Mandalong Southern Extension Project SSD5144

Submission for Mandalong Community Association (MCA)

Draft date: 11 December 2013

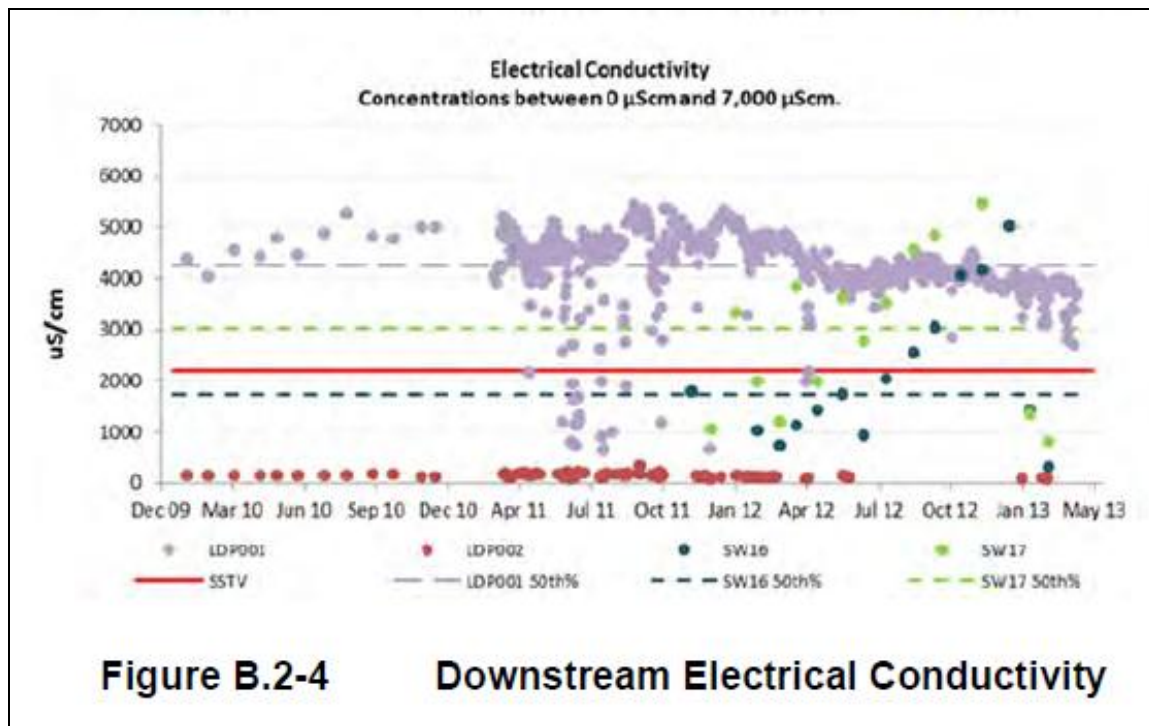
Salinity: There was inadequate upstream salinity data presented from sites SW13, SW14 and SW15, with only data from July 2011 to early 2013. It was difficult to interpret the data from visual assessment of the figure 'B.2-3'; but electrical conductivity was mostly less than 500 $\mu\text{S}/\text{cm}$ upstream of the project discharge site. In contrast, salinity downstream of the mine discharge was much higher.

Figure B.2-4 (from Appendix B) shows that a much more detailed dataset is available for sampling sites downstream of the mine discharge, with data from 2009 to early 2013 and very detailed regular observations from April 2011. This figure clearly shows that salinity levels are highly elevated below the mine and at site LDP001 are generally in the range 3000 to 5000 $\mu\text{S/cm}$. Such levels are indicative of saline pollution and are 10 to 16.6 times higher than the ANZECC (2000) trigger value for ecosystem protection. Although saline data collected upstream was inadequate, nonetheless the limited data was generally less than 500 $\mu\text{S/cm}$ and demonstrates that the mine discharge is causing significant salinity pollution.

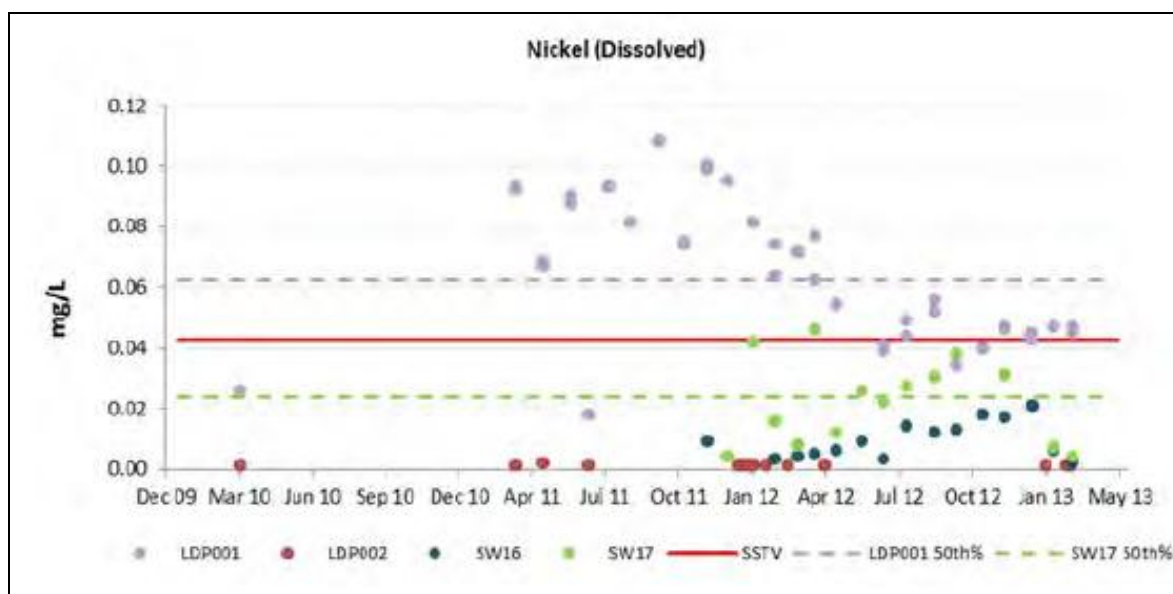
Figure B.2-27 (Nickel (Dissolved)) shows that downstream concentrations were highly elevated. Appendix B reports that nickel levels were below 0.04 mg/L. The mine discharge (LDP001) had nickel (dissolved) concentrations often higher than the 0.04 mg/L trigger value. This indicates that the mine is causing nickel pollution at levels hazardous to aquatic ecosystems. ANZECC guidelines suggest that nickel may be hazardous at levels of 0.008 to 0.017 mg/L. Hardness data is not provided to enable an

assessment of the appropriate ANZECC 'Hardness Corrected Nickel Trigger Value' for nickel levels and protection of aquatic ecosystems.
